Technical Service Bulletin: TSB120240

New Dual Impeller Water Pumps With Weep Hole Filter

This document announces the release of new dual impeller water pumps for use on QSK38, QSK50, and QSK60 Modular Control Rail System (MCRS) engines.

Figure 1, New water pump with weep hole relocated and filter installed.

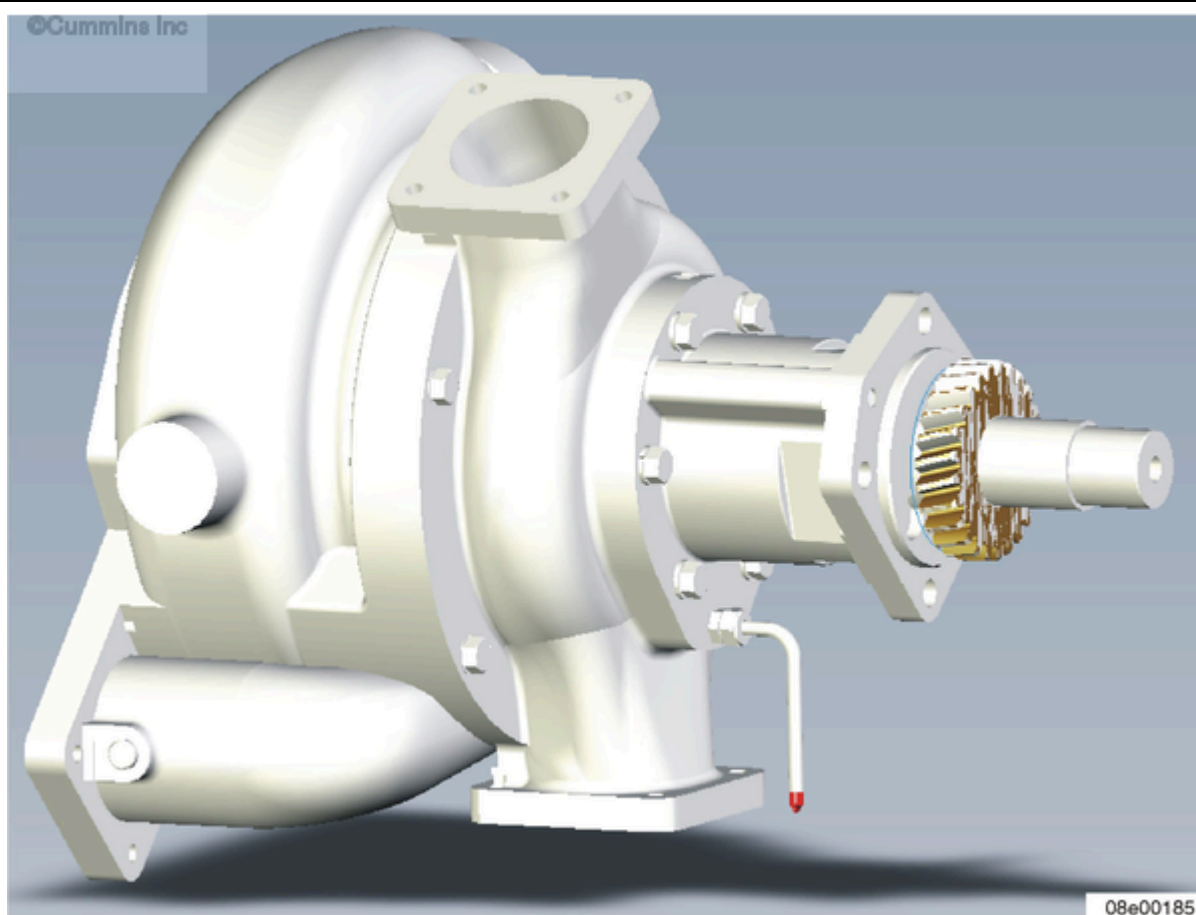
The new water pumps incorporate a relocated and threaded weep hole to allow for the installation of a weep hole filter assembly. The filter has been added to prevent debris from entering the weep chamber, to increase the reliability of the pump. Refer to Figure 1 below for illustration of the new water pump with revised weep hole location and new weep hole filter installed.

Note : With the relocation of the weep hole on the new water pumps, an occasional coolant drip may be seen coming from the filter. This is normal and does not indicate a leaking pump.
